TECHNICAL SERVICE BULLETIN

"Steering Assist Fault Service Required" Message In The IPC And Reduced Steering Assist With DTCs U3008:1B And/Or U3009:1B Stored In The PSCM

26-2150

This bulletin supersedes 26-2035. Reason for update: update the Service Procedure to add figures 1, 2, 5 and 6 to clarify the ground location, update Steps (13-15, 21-22), and update the Parts list according to the type of vehicle variant and repair.

Figure 1 - Vehicles equipped with 2.3L engine

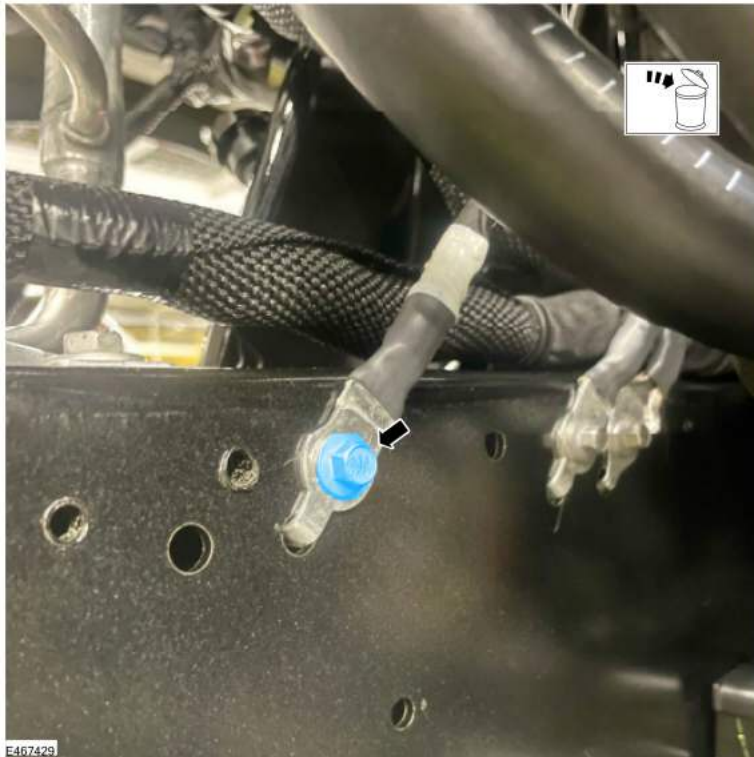
6. Remove and discard the M6 fastener from ground G104 (Explorer/Police Interceptor) or G116 (Aviator) on the passenger side frame rail. Refer to Wiring Diagram Cell 151 for connection locations. (Figures 1-2)

7. Carefully enlarge the existing holes in the frame rail sheet metal and the harness eyelet by drilling with a 7 mm (9/32 in) drill bit.
8. Reinstall ground G104 (Explorer/Police Interceptor) or G116 (Aviator) using the new self-tapping M8 fastener. Make sure the ground eyelet locating tab is properly aligned with the alignment hole in the frame. Tighten to 71 lb.in (8.0 Nm).

Figure 2 - Vehicles equipped with 3.0L and 3.3L engine

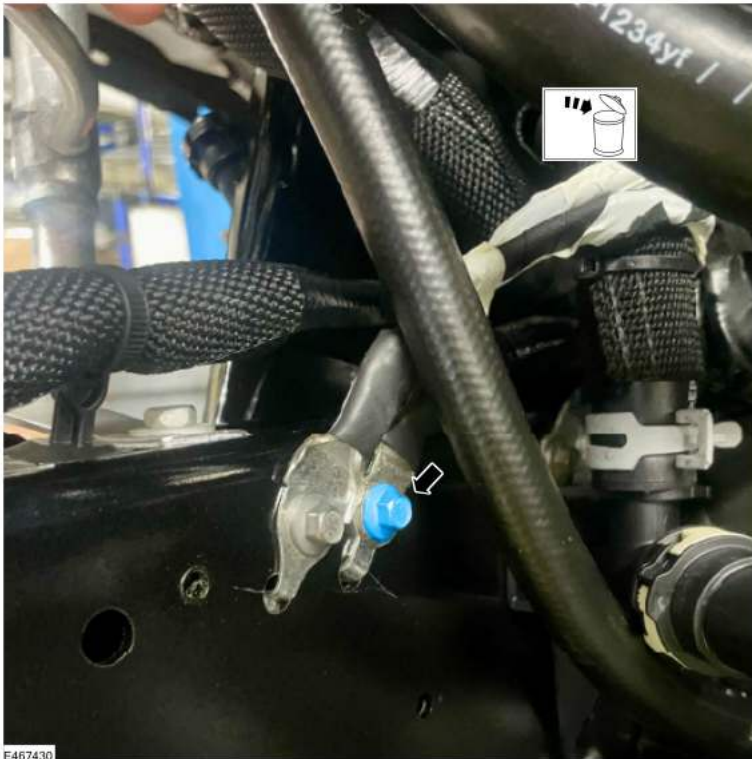
NOTE: The position of the ground eyelets shown may vary. The suspect ground is the smaller of the 2 eyelets.

Figure 5

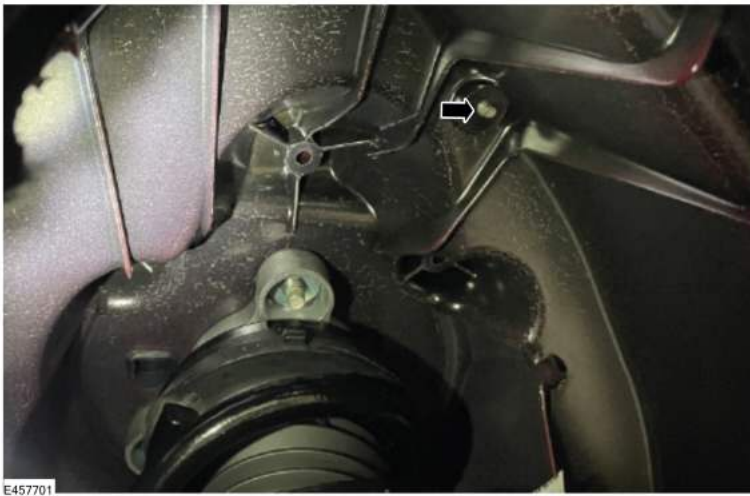
- 14. On Aviator vehicles, install the new M6 stud bolt on ground G119. Tighten to 154 lb-in (17.5 Nm).
- 15. On Explorer/Police Interceptor vehicles, tighten the existing M6 bolt on ground G103 on the passenger side shock tower to 154 lb-in (17.5 Nm). (Figure 5)
